NERPM Version 1.2

Summary of Changes

Appendix A

CR 16A and Johns Island Parkway subarea network and TAZ updates

Figure 1: NERPM 1.2 Network updates

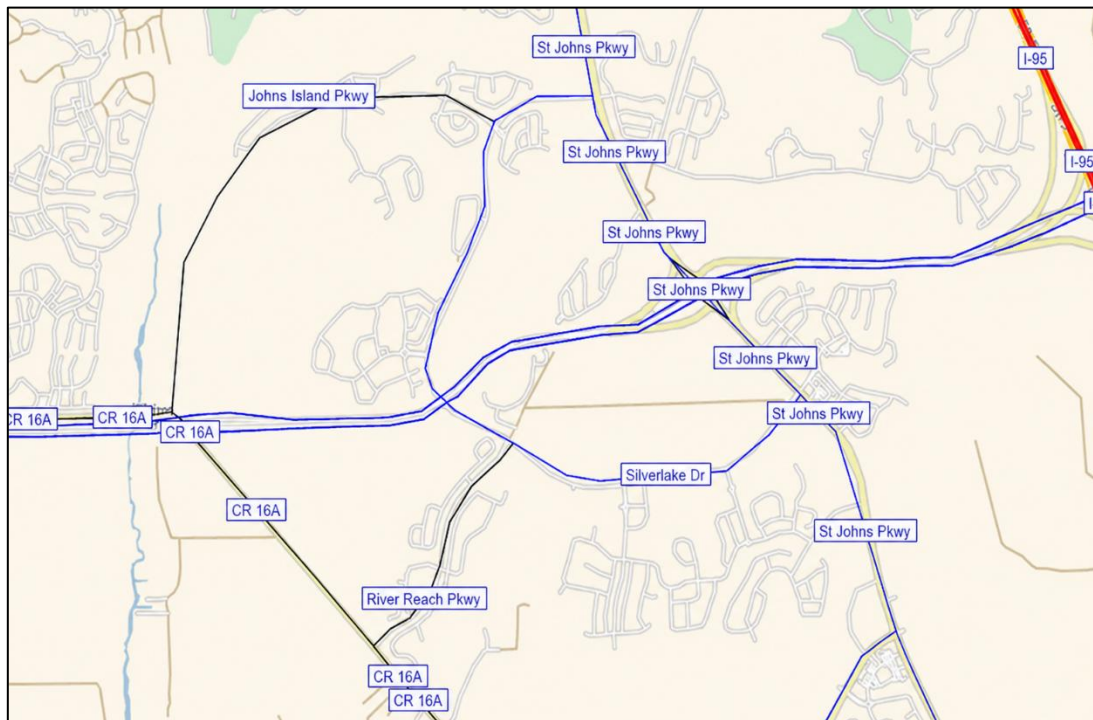
1. Silverlake Drive was coded as a four-lane road
2. River Reach Parkway was coded as a two-lane road to provide a connection between CR 16A and Silverlake Drive
3. Johns Island Parkway was coded as a two-lane road between CR 16A and Silverlake Drive

Figure 2: NERP 1.2 TAZ updates

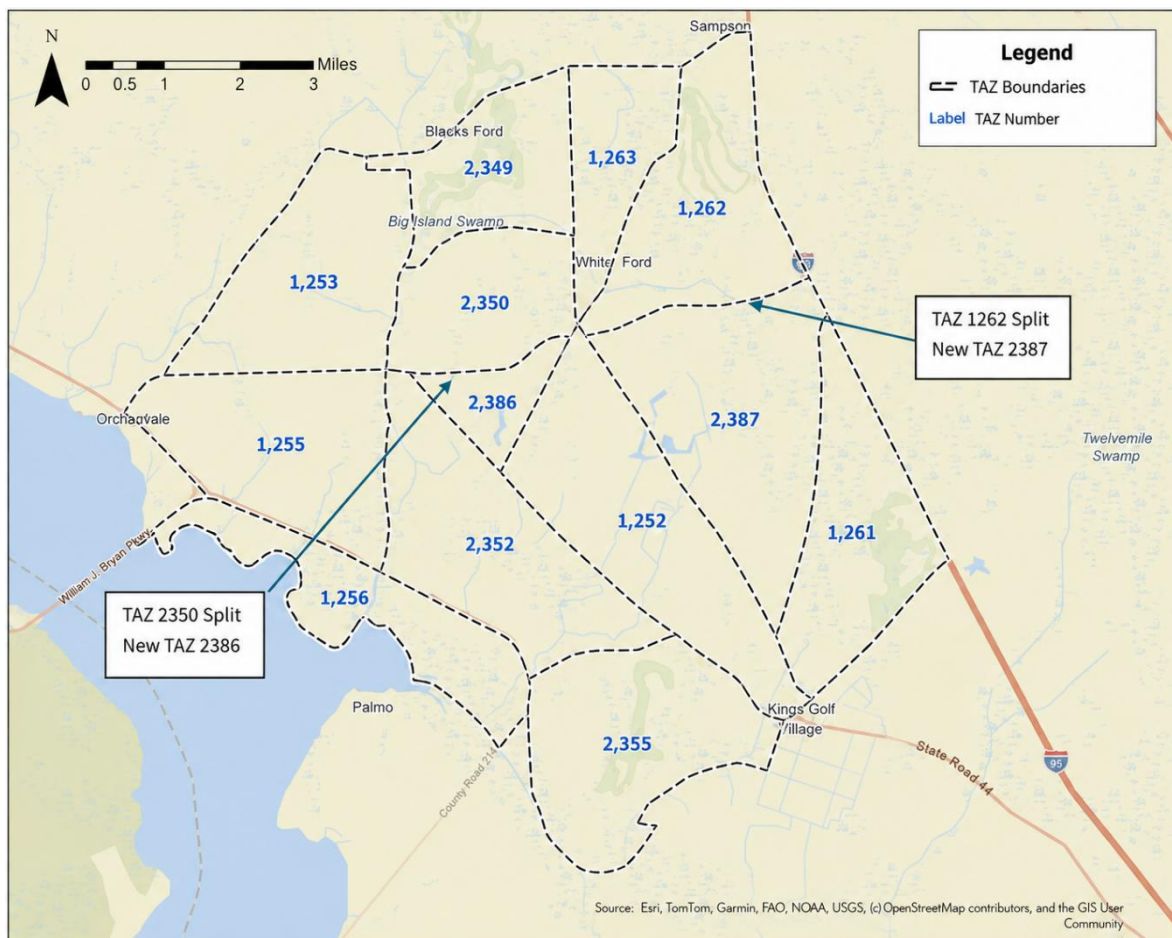
4. TAZ 2350 was split into two TAZ's along the First Coast Expressway:

- a. The northern portion of the split was assigned to TAZ 2350
 - b. The southern portion of the split was assigned to TAZ 2386
5. TAZ 1262 was split into two TAZ's along the First Coast Expressway:
 - a. The northern portion of the split was assigned to TAZ 1262
 - b. The southern portion of the split was assigned to TAZ 2387
6. A network correction was made for the First Coast Expressway. Previously, some portions were coded as one lane roadway. In this corrected version, those portions are coded as two lanes.
7. Centroid connectors were added as needed.

9. Plantation Oakside Blvd - lane corrections (2 lanes to 1 lane; 1 lane to 2 lanes)

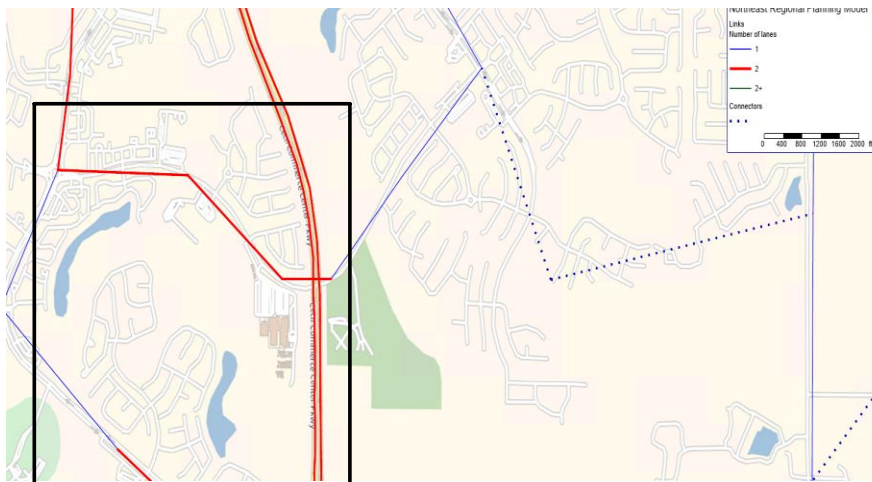
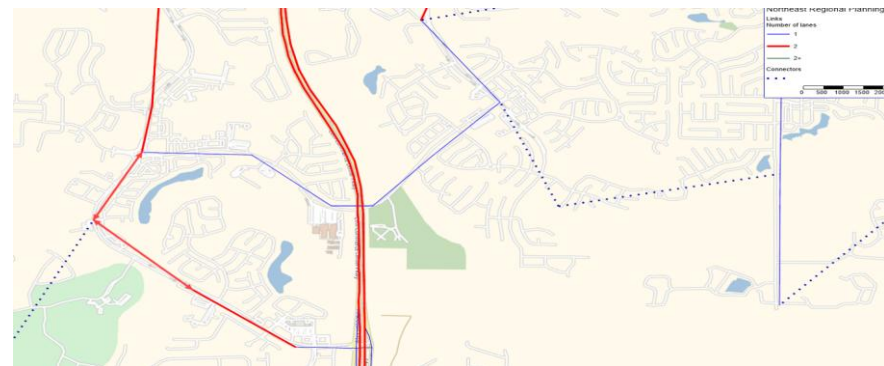
Plantation Oakside Blvd near First Coast Expressway: one link changed from 2 lanes to 1 lane and another from 1 lane to 2 lanes.

Existing condition: The upper/western affected link was red (2 lanes), while the lower-left diagonal link was blue (1 lane).

Update made: The upper/western link was changed to blue (1 lane), and the lower-left diagonal link was changed to red (2 lanes).

10. Zone 1460 - connector relocation

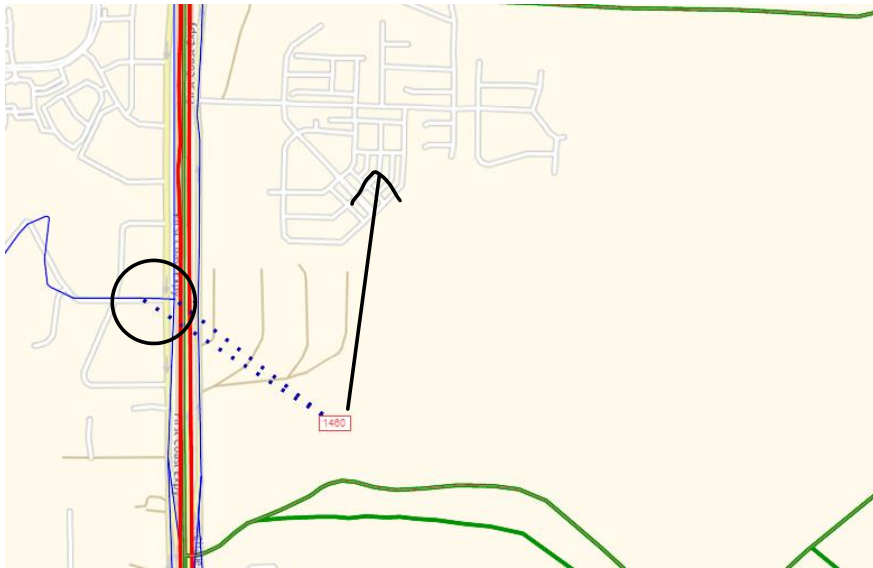
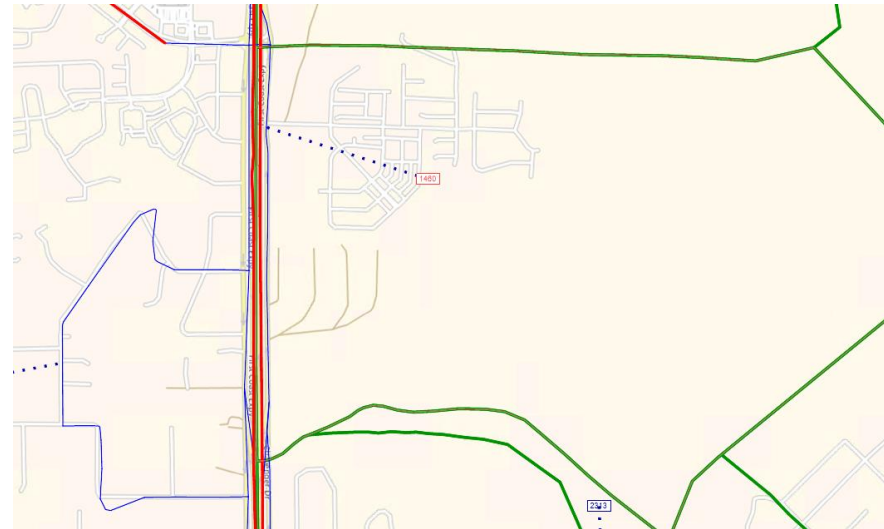
Zone 1460 centroid connector relocated to the corrected local-street connection.

11. First Coast Expressway near Trail Ridge Rd - northbound lane correction (1 lane to 2 lanes)

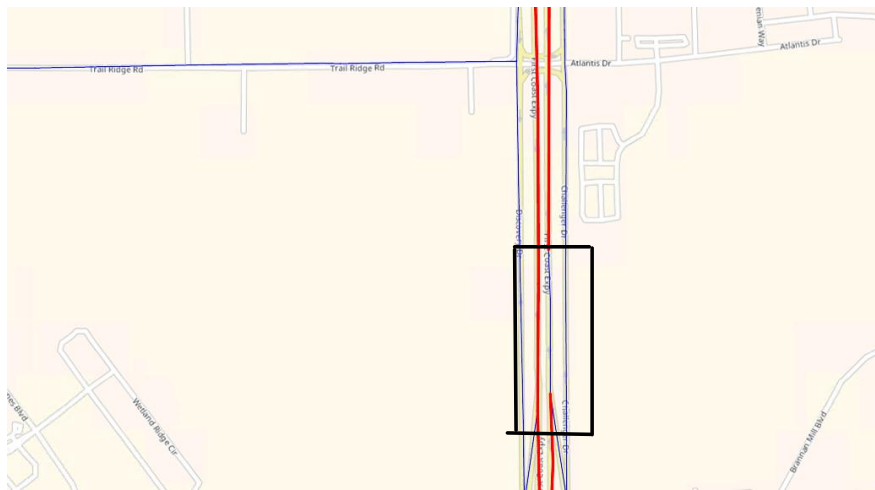
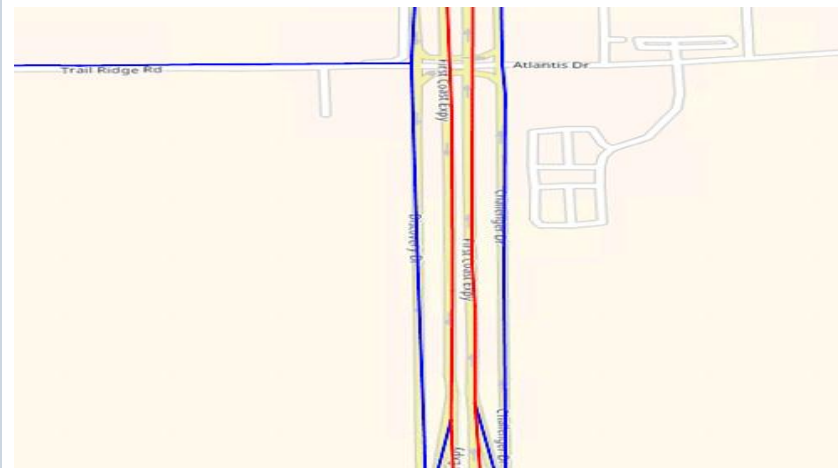
Network change: The northbound First Coast Expressway segment near Trail Ridge Rd was changed from 1 lane to 2 lanes. In the displayed symbology, blue = 1 lane and red = 2 lanes.

Existing condition: The marked northbound segment was coded blue (1 lane) in the existing network.

Update made: The same northbound segment is coded red (2 lanes) in the updated network.

12. Zone 1479 - centroid relocation

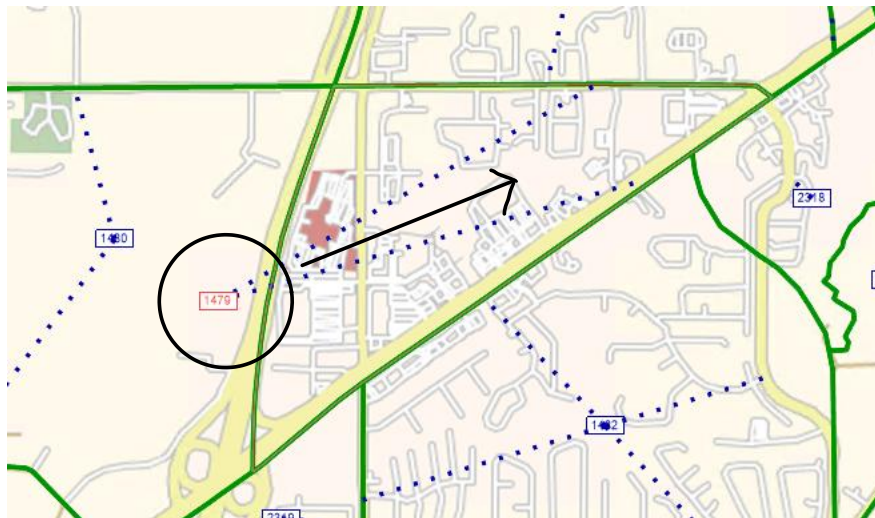
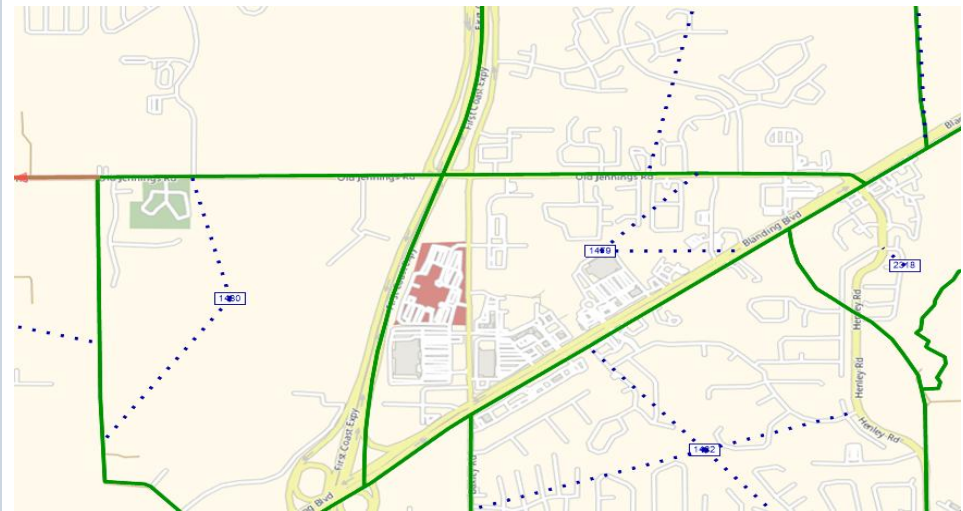
Zone 1479 centroid and connectors relocated within the TAZ boundary.

Existing condition: The Zone 1479 centroid was positioned outside the TAZ boundary in the existing network.

Update made: The centroid was moved inside the TAZ boundary near the served development, and the dotted-blue connector routing was reoriented to the new centroid location.

13. Argyle Forest Blvd / Cecil Commerce Center Pkwy - lane correction (2 lanes to 1 lane)

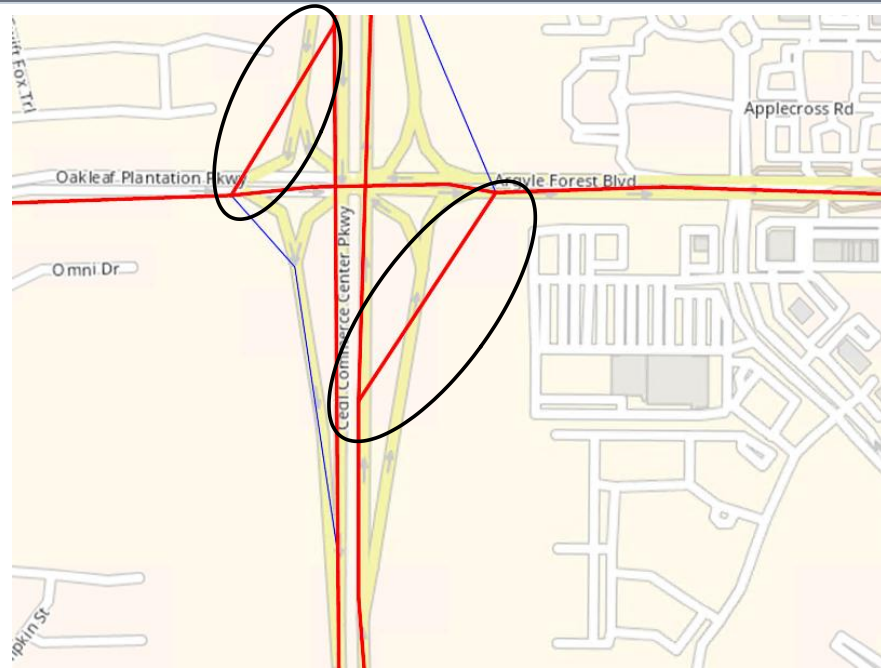
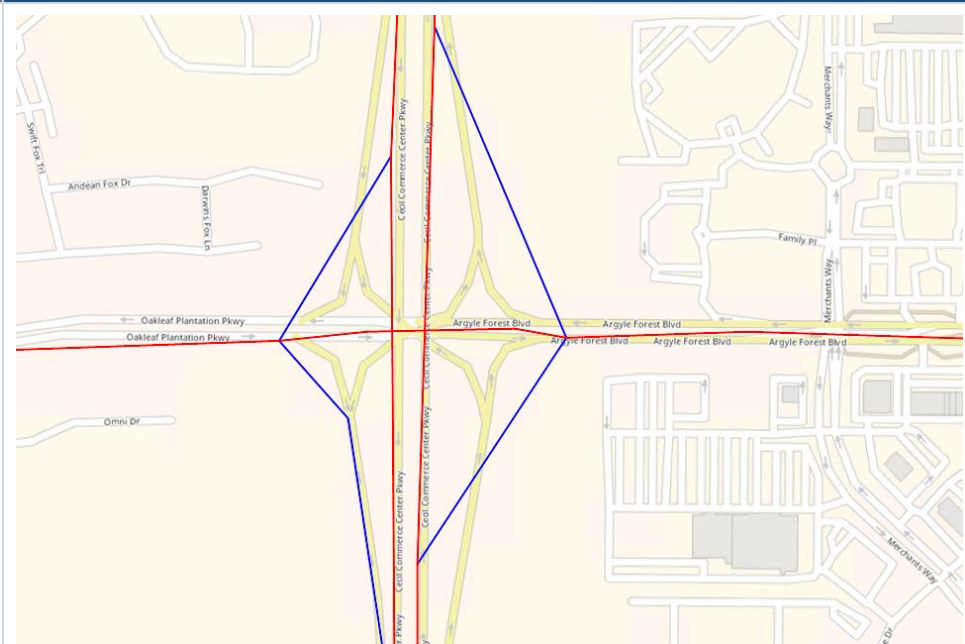
Network change: The marked Argyle Forest Blvd / Cecil Commerce Center Pkwy ramp/link segments were changed from 2 lanes to 1 lane. In the displayed symbology, blue = 1 lane and red = 2 lanes.

Existing condition: The marked ramp/link segments were coded as 2 lanes in the existing network.

Update made: The marked ramp/link segments were changed to 1 lane in the updated network while the adjacent mainline coding remained unchanged.

14. First Coast Expressway – Lane correction from 1 lane to 2lanes

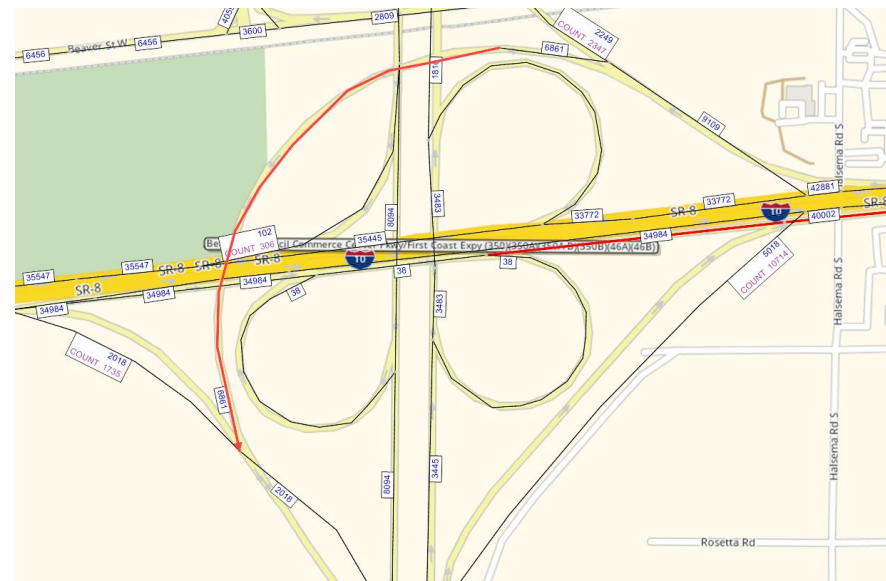
Network change: The 2050 First Coast Expressway near County Road 209 S was changed from 1 lane to 2 lanes. In the displayed symbology, blue = 1 lane and red = 2 lanes.

16. Halsema Rd / I-10 - southeast ramp realignment

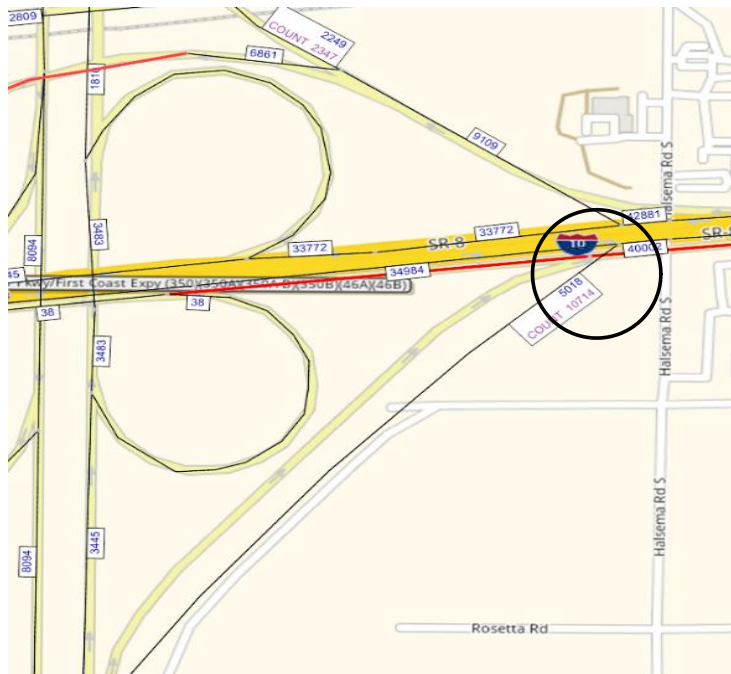
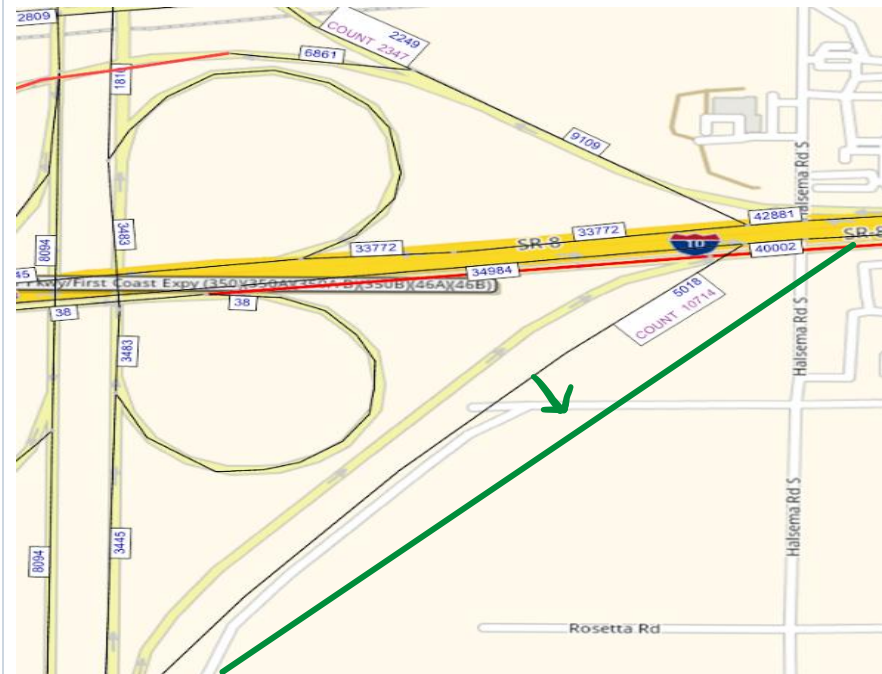
Network change: The southeast ramp/link in the Halsema Rd / I-10 area was shifted from the previous alignment to the green-marked alignment.

Existing condition: The existing ramp/link followed the earlier southeast alignment shown at the marked interchange location.

Update made: The southeast ramp/link was realigned to follow the green-marked path shown in the updated screenshot.

17. Normandy Blvd / Cecil Commerce Center Pkwy – update connection geometry and turn penalties

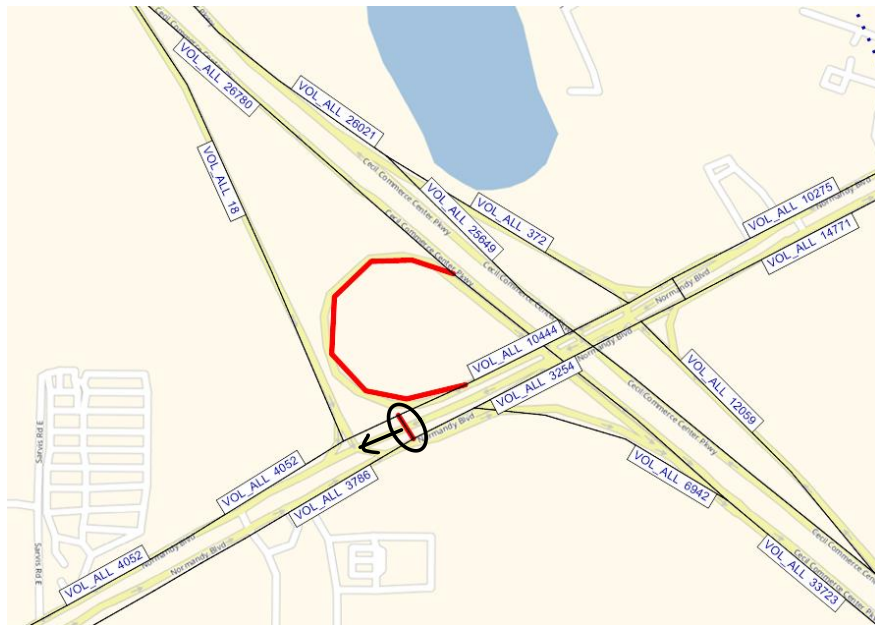
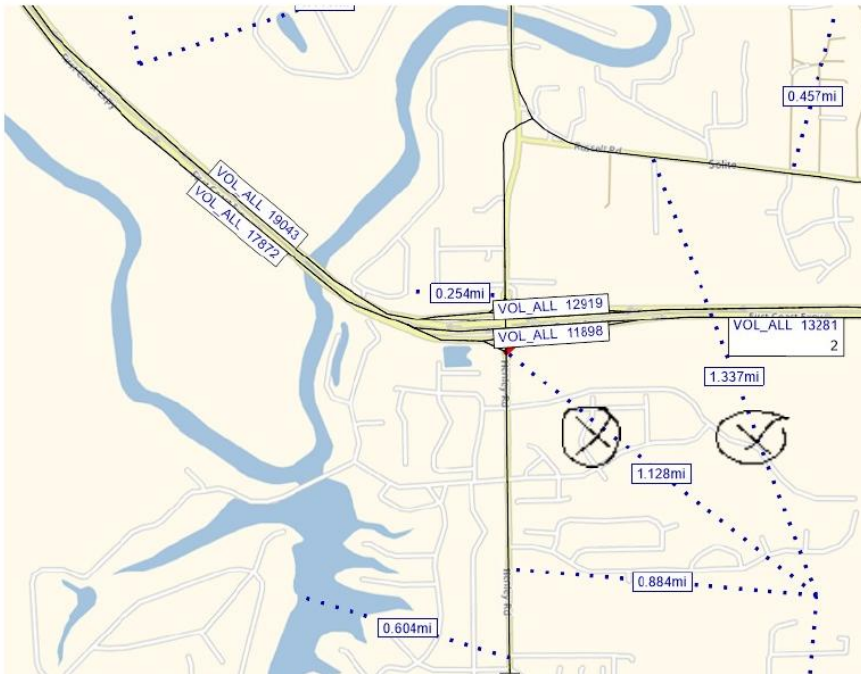
Network change: The Normandy Blvd / Cecil Commerce Center Pkwy interchange connection geometry was reshaped and reattached at the corrected junction and turn penalties updated for the highlighted links

Existing condition: The existing diagonal connection joined the roadway at the circled point.

Update made: The connection was reshaped and reattached at the corrected junction shown by the green mark in the updated network.

18. First Coast Expressway area / Henley Rd interchange TAZ's connectors are updated

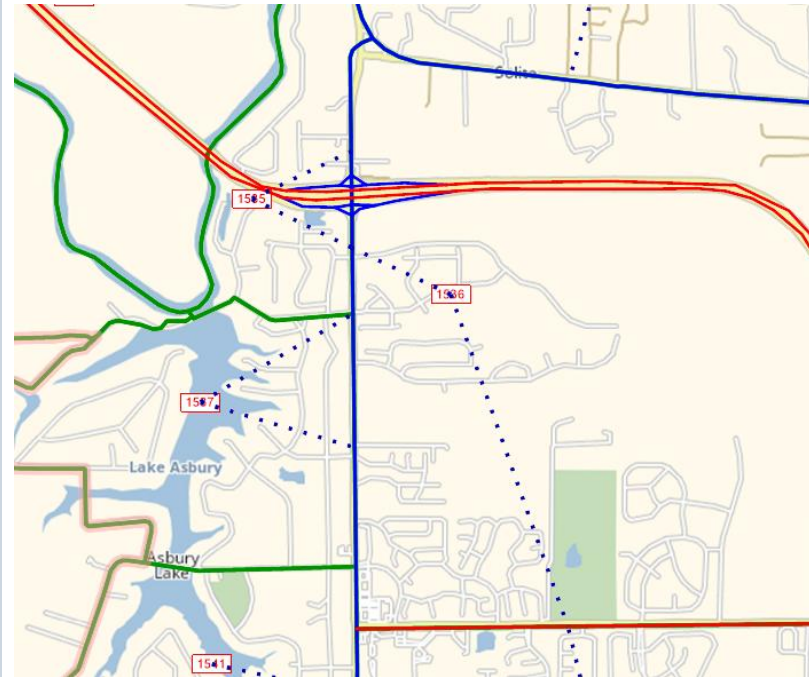
Network change: 1535, 1536, 1537 TAZ's connectors are updated as shown in right side figure.
